Memorandum

From: John Morgan Jr., P.E., PTOE
Section Manager
CHA Consulting, Inc.

RE: Updated Response to Public Comments
Revere Street Roadway Project
MassDOT Project # 607244

Parking Accommodations

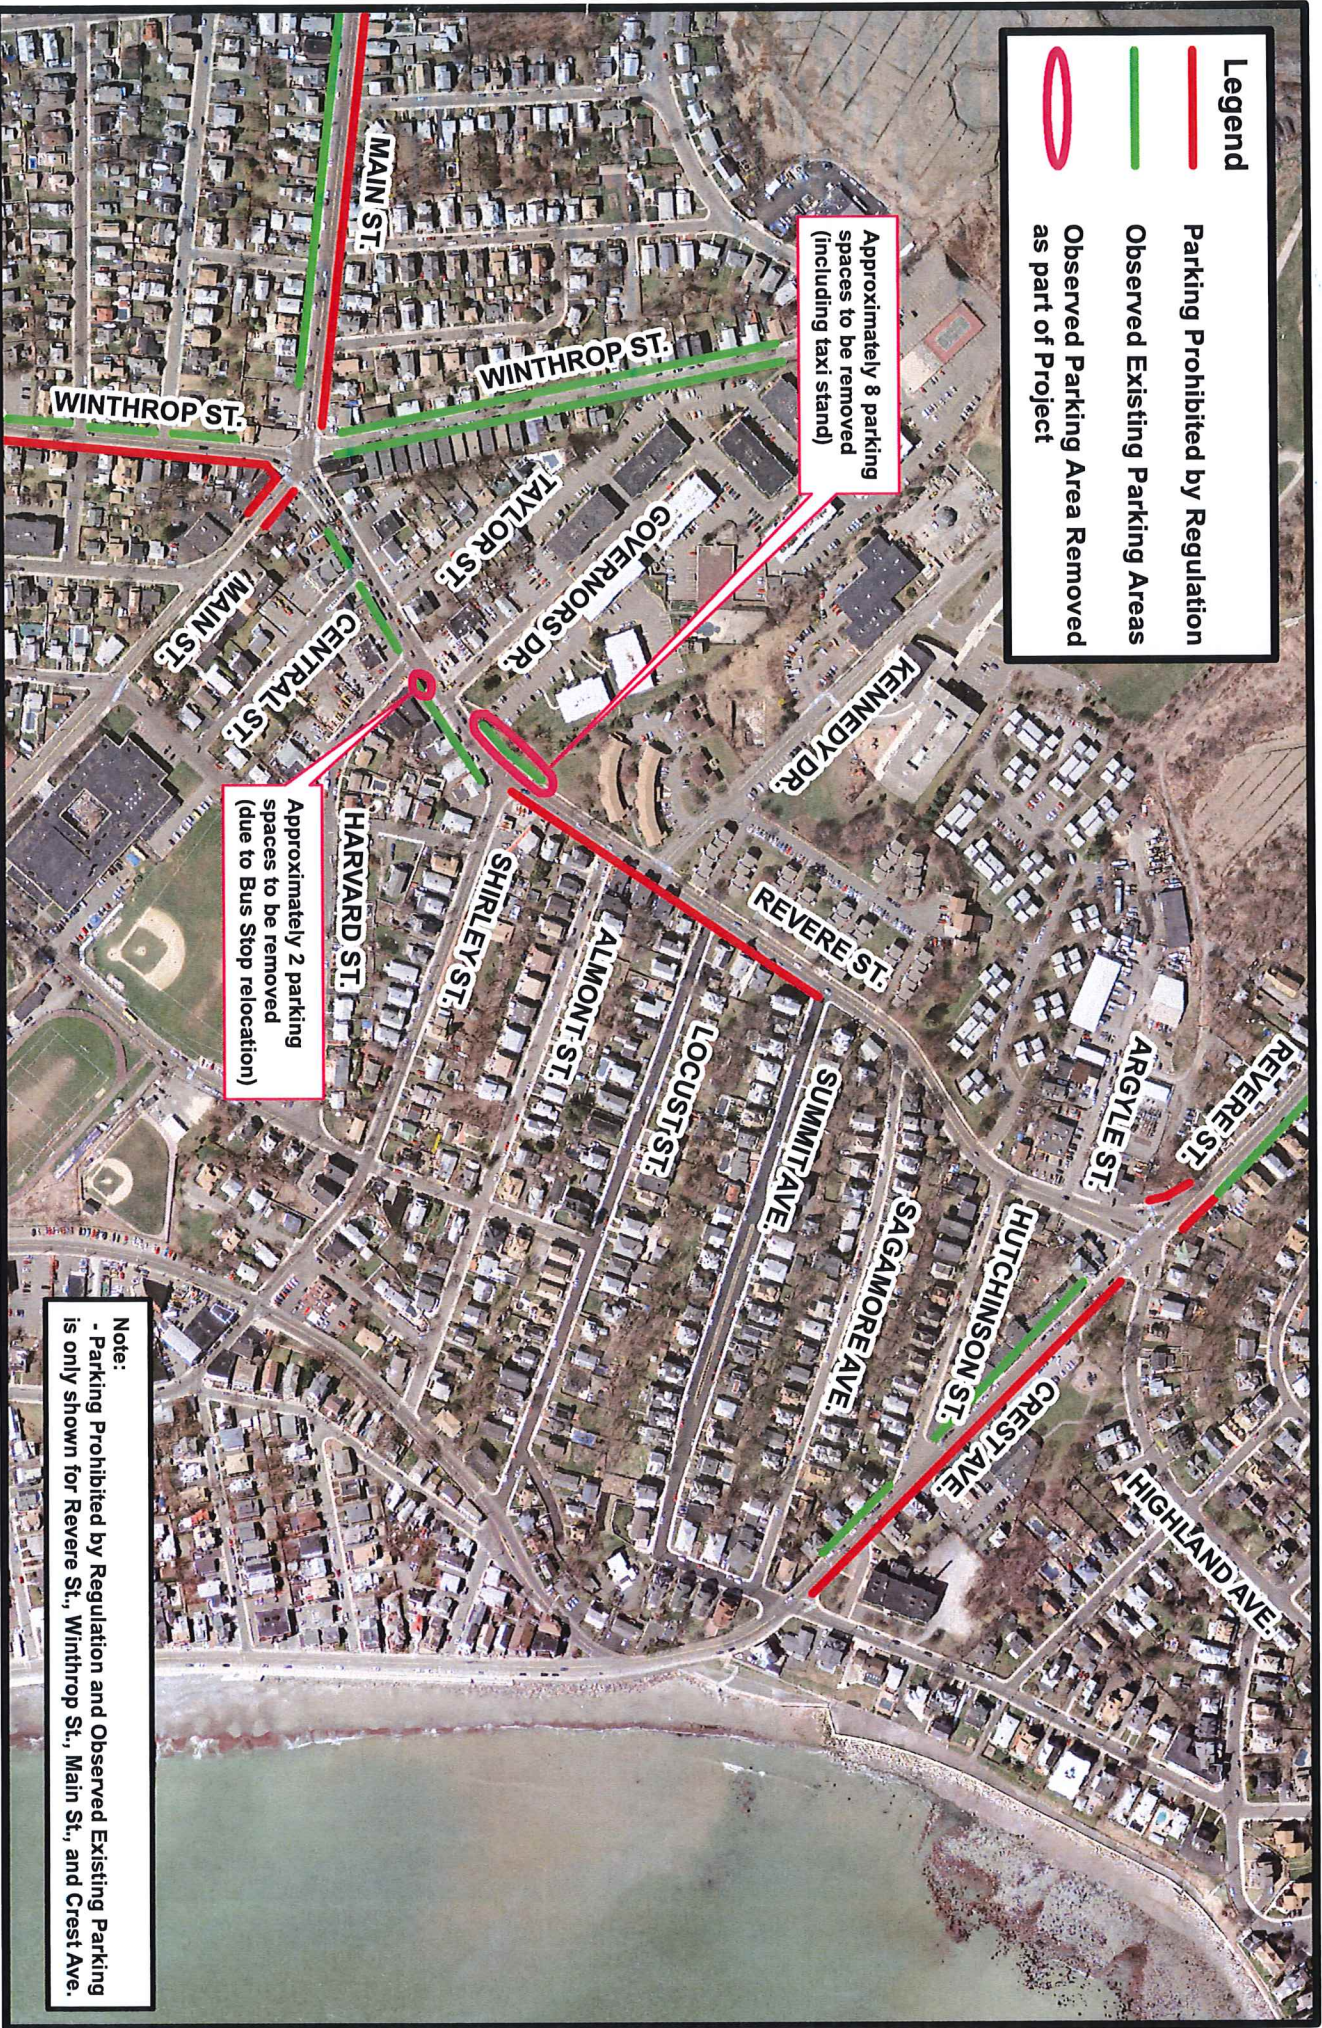
2. *How many parking spaces are being lost as a result of the project?*

How vehicles park on Revere St. today is often inconsistent with legal parking regulations. Parking signage is unclear in areas and is also sometimes inconsistent with the parking regulations. The attached figure shows where parking is prohibited by Town ordinance, where parking is actually utilized by our observation and discussion with the Town, and where parking that is used today will be removed as a part of the project. [The result is approximately 10 on-street parking spaces will be lost.](#) However, please note that the 2 parking spaces to be removed due to the bus stop relocation on the east side Revere Street near Harvard Street will be re-instated once the MBTA discontinues Route 712 and these bus stops which is anticipated to occur over the next 5 years.

It is also important to note that parking in an intersection, as is currently allowed at the Shirley Street intersection, and parking within 20 feet of a crosswalk, is not a safe condition for vehicles and pedestrians and should be removed regardless of the decisions made around bicycle lanes and bus stops. This alone accounts for about 5 parking spaces that should be removed.
